NOTICE UNDER SECTION 96 OF ACT III OF 1901.

I beg to inform you that I intend building on a second floor
over the new portions in Jamait Khana on plot No. 60
 Survey Sheet No. A 12 situate in Chandni
 Street, Machhi Miani Quarter.

PLAN
SHOWING PROPOSED ADDITION
ON PLOT NO: 60 SHEET A/2
MUCHEE MEANI QUARTER
SCALE 8 FT = 1 INCH

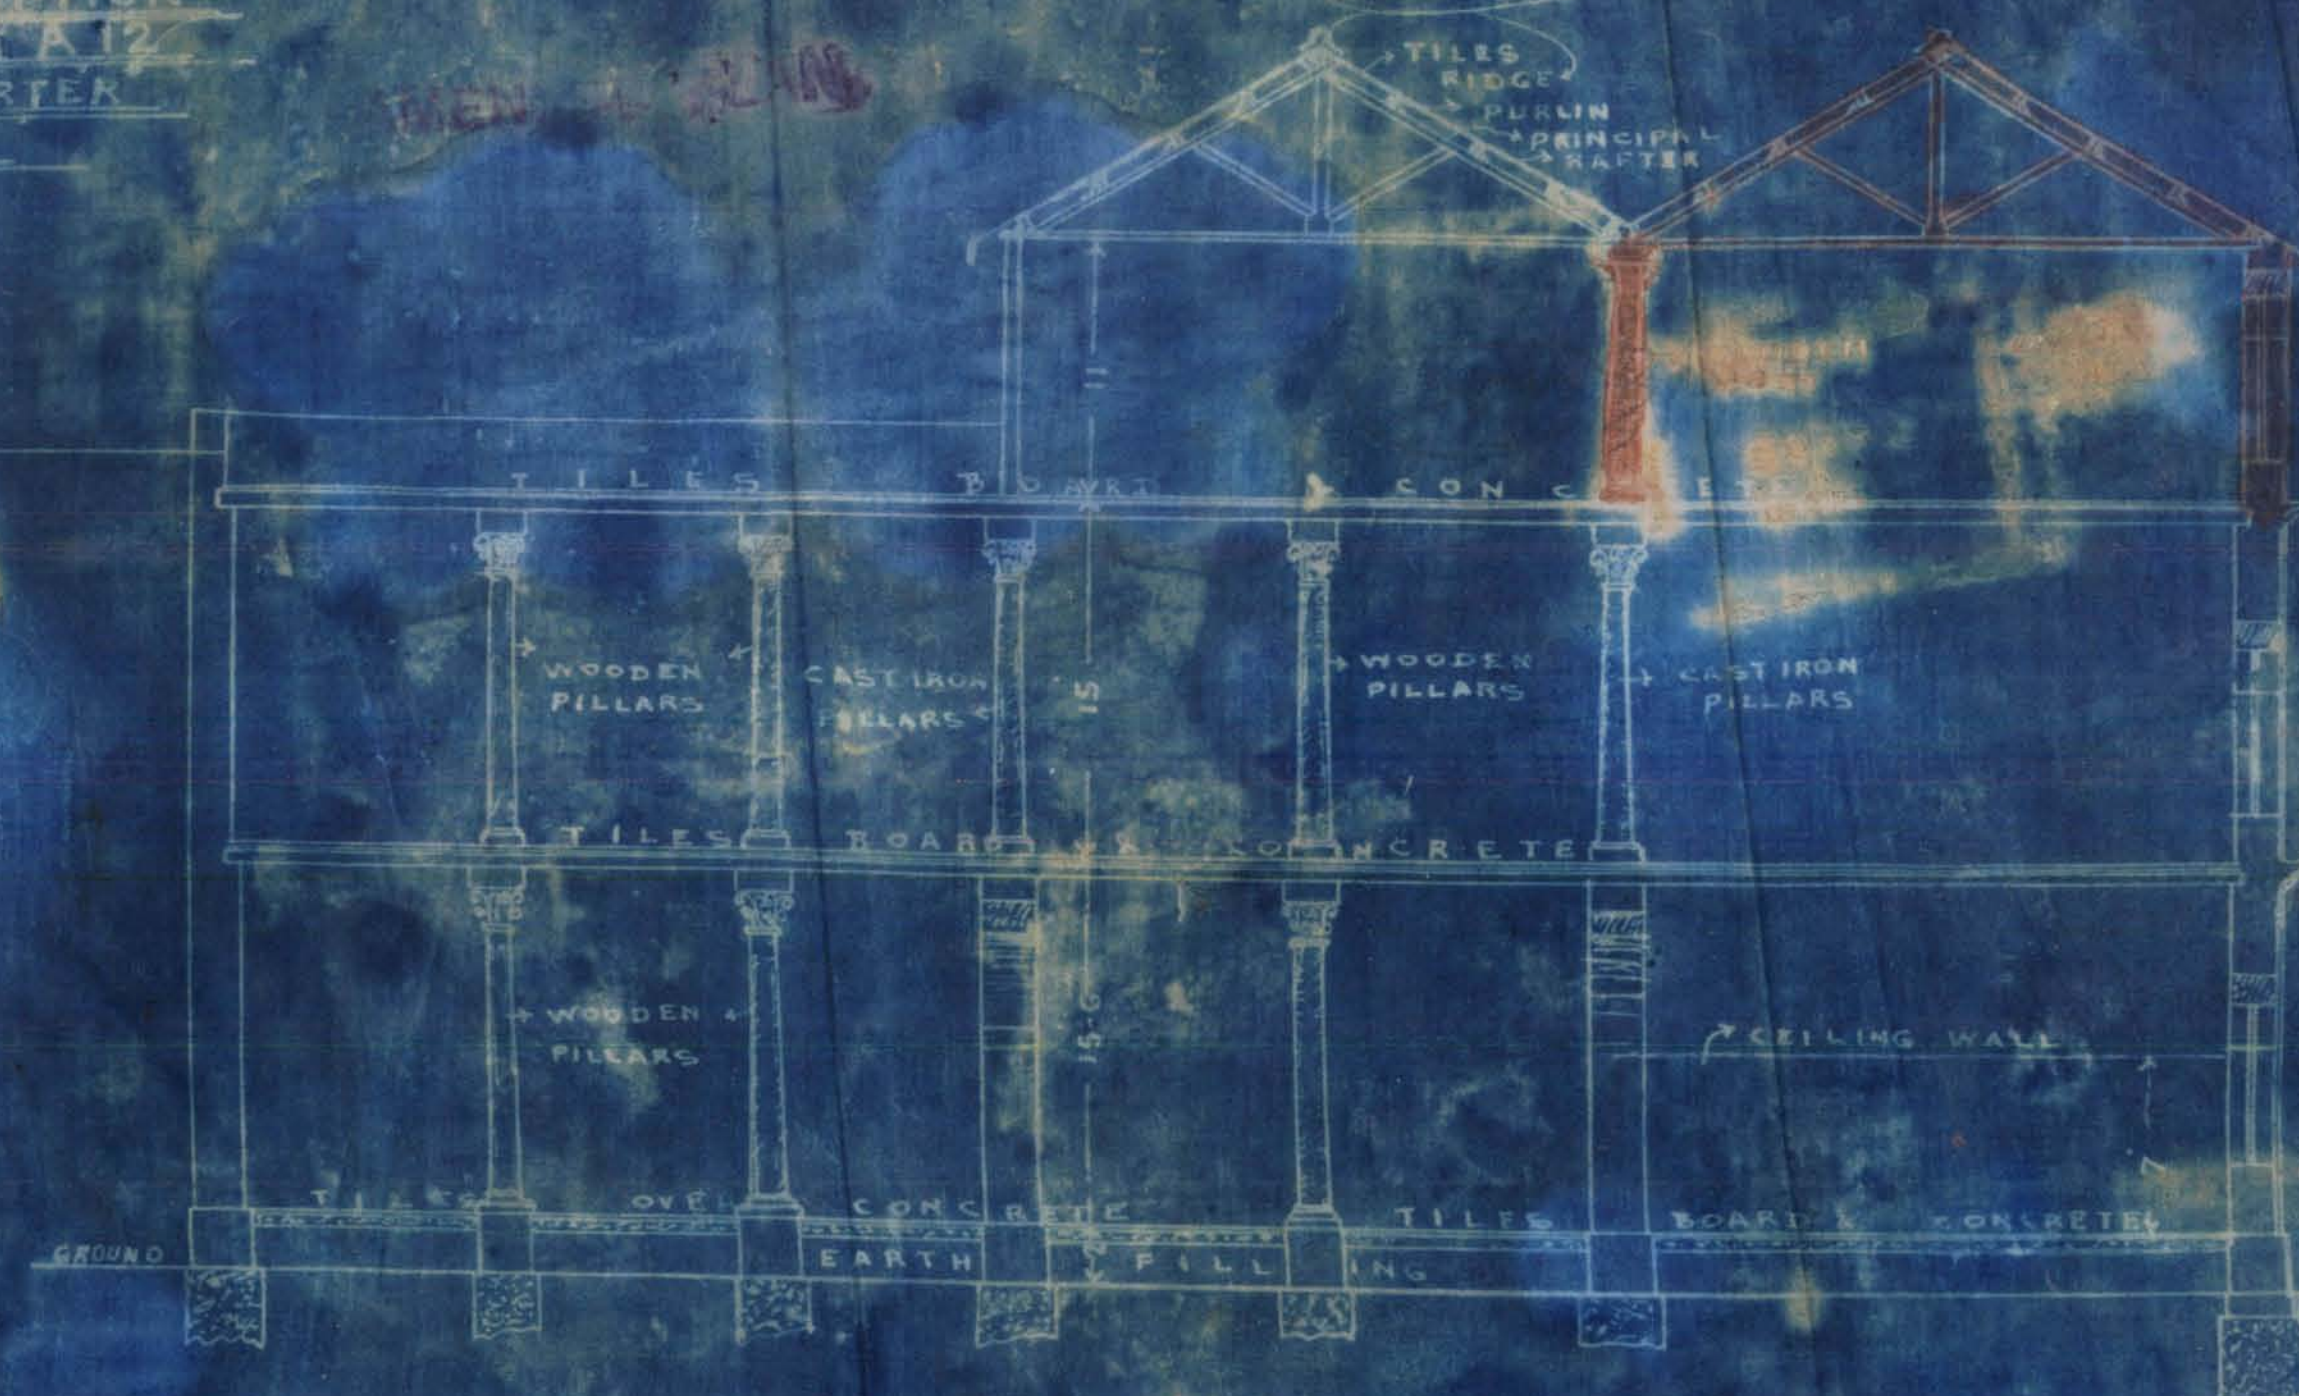
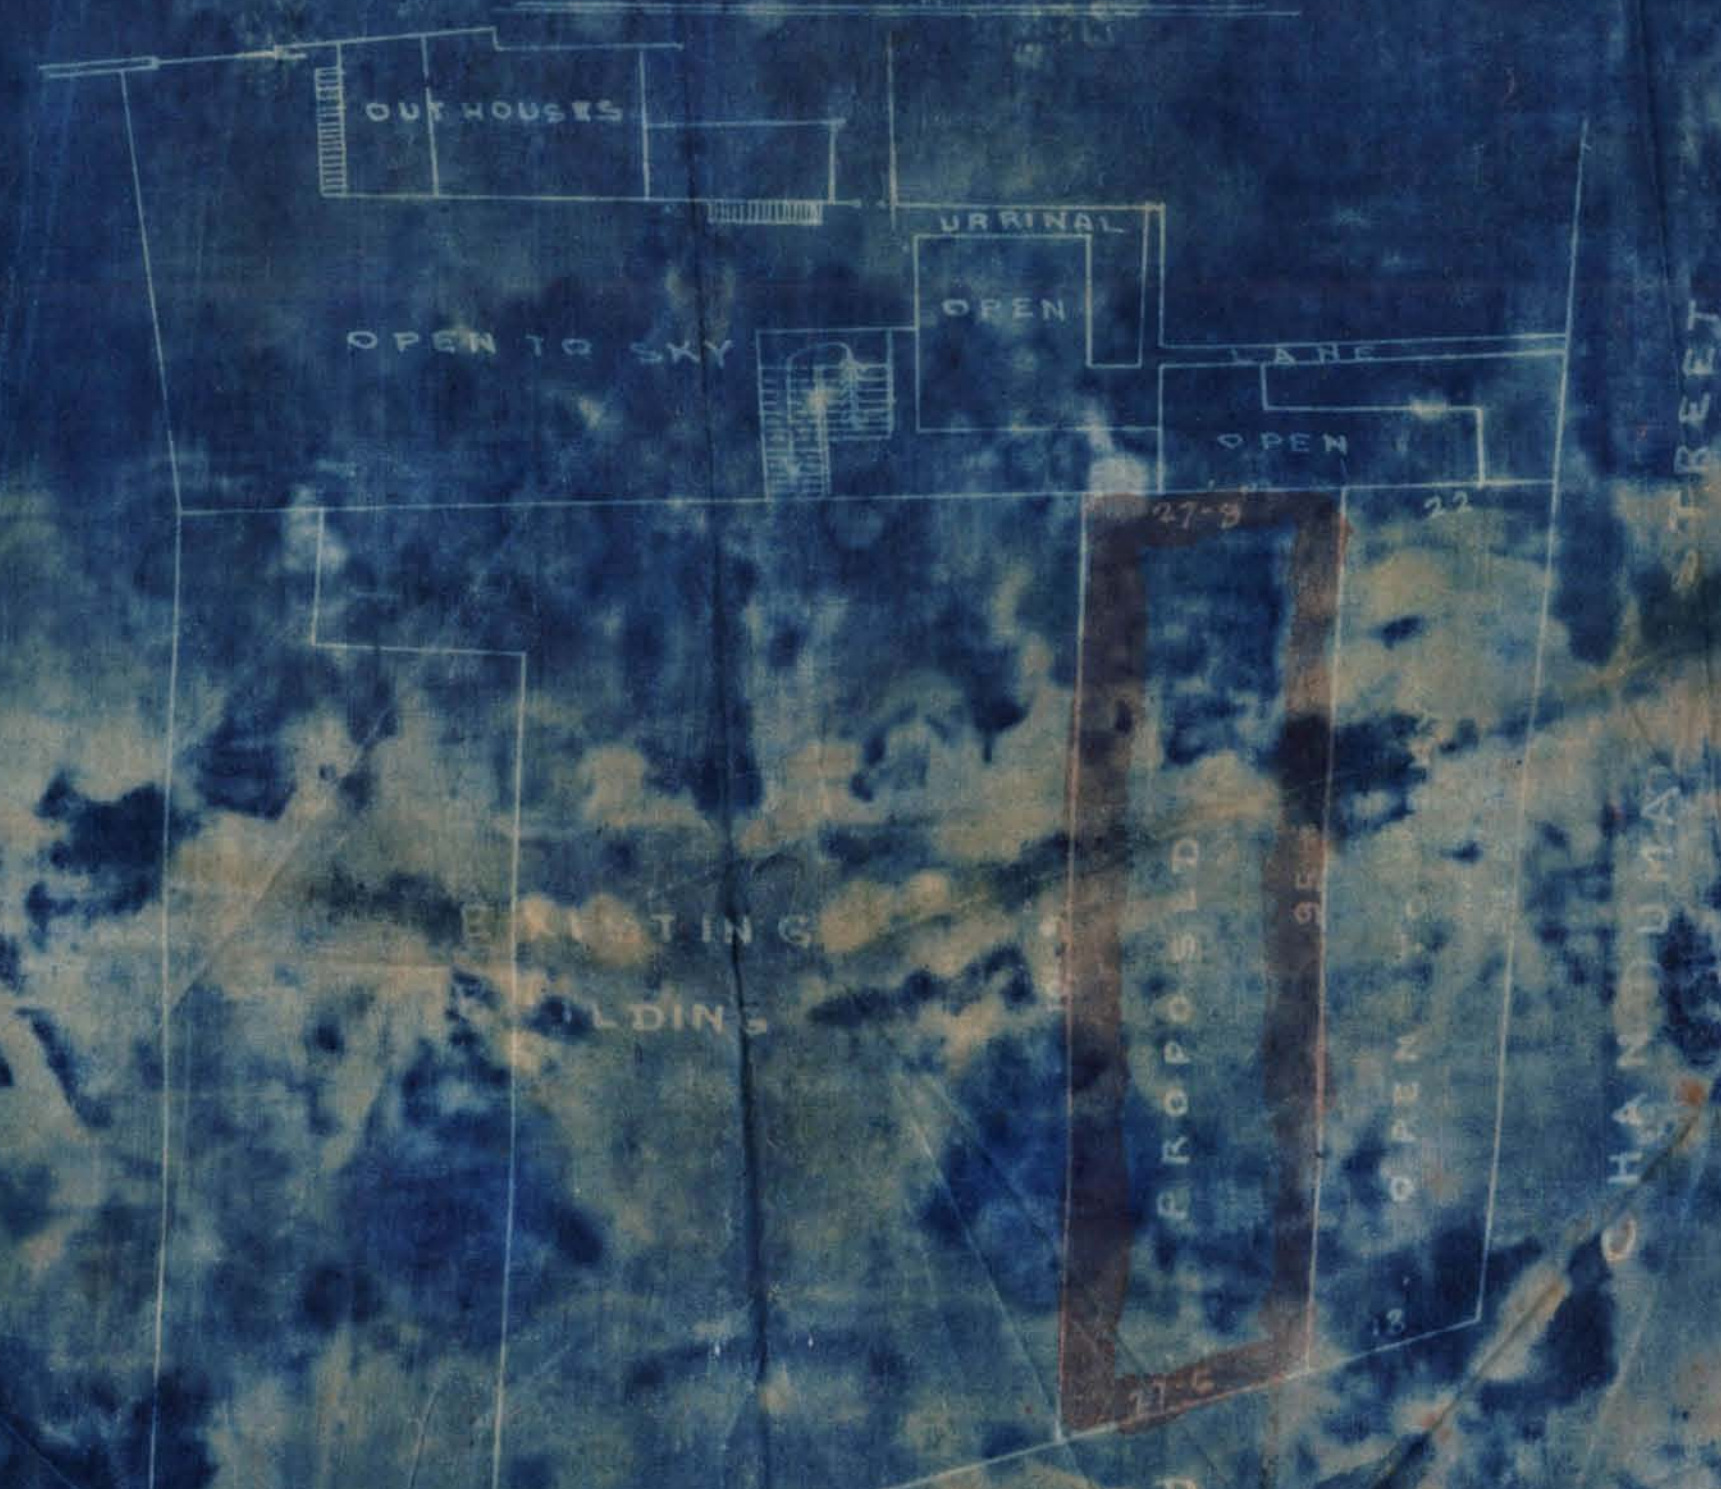
No objection

I beg to report that there appears no
objection to approve the plan with
the consent

Remarks Sir, I beg to report that there seems
no objection to grant pass with the
city some collection consent.

With reference to his application dated 30th June 1917 with a set of plans for plot No. 60, A-12 Muchi Meani Quarter Vazir Kasria Budoo is requested to apply for permission to the City Deputy Collector with two copies of plans returned herewith duly signed and approved, He must not start any building operation until he hears further from this office.
